# SAN DIEGO STATE UNIVERSITY MISSION VALLEY CAMPUS MASTER PLAN FINAL ENVIRONMENTAL IMPACT REPORT VOLUME I - COMMENT LETTERS

5500 Campanile Drive  
San Diego, California 92182-1624  
*Contact: Laura Shinn*  
SCH. No. 2019011042

January 2020

Proposed Road Leaving Project Elevates Over Corridor

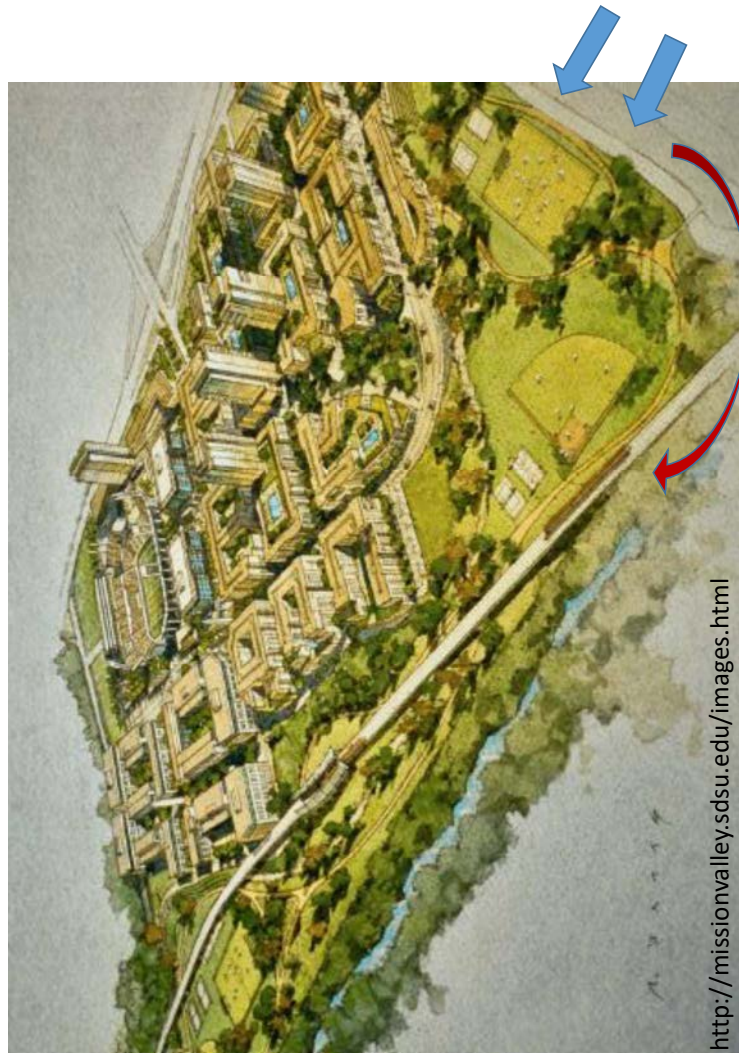
- Road Leaving Project Eastward Spans Wildlife Corridor
- Widen and Improve Wildlife Corridor at SDSU Mission Valley
- Allow Access Under Roads/Bridges and Low Impact Lighting
- Widen and Improve Wildlife Corridor along Murphy Canyon Pathway
- Allow Animal Movement across Cement Culvert
- Promote Multi-Use Pathway for Animals and Citizens
- Advocate for Pathway to be Closed from Dusk to Dawn to Allow Larger Animals Access for Nighttime Movement

Widen Animal Corridor up to 6 Feet for Smaller Animals

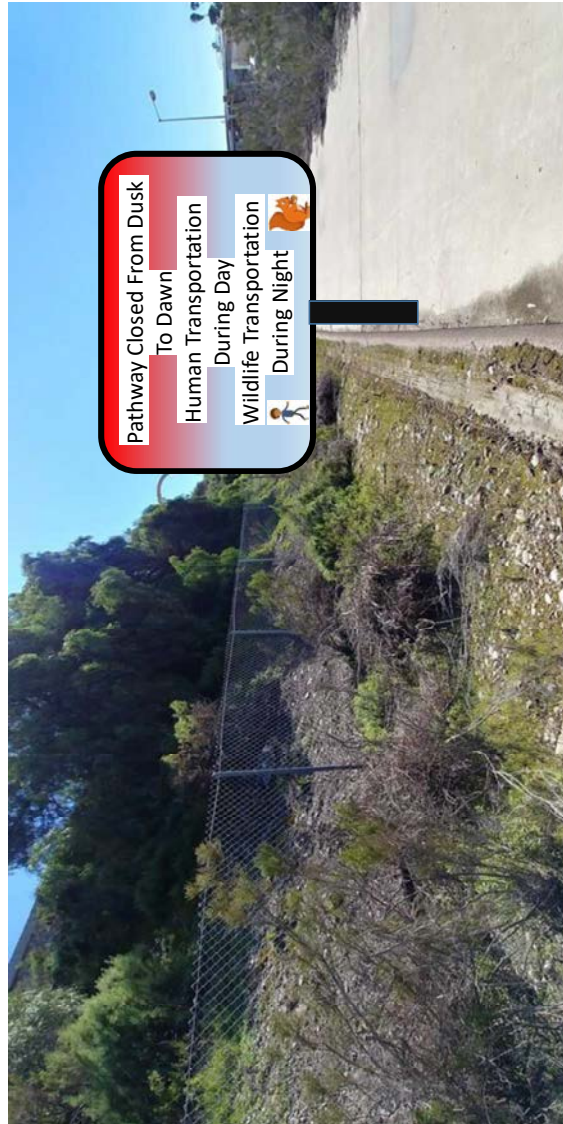
Replace With 6 Feet of Native Habitat
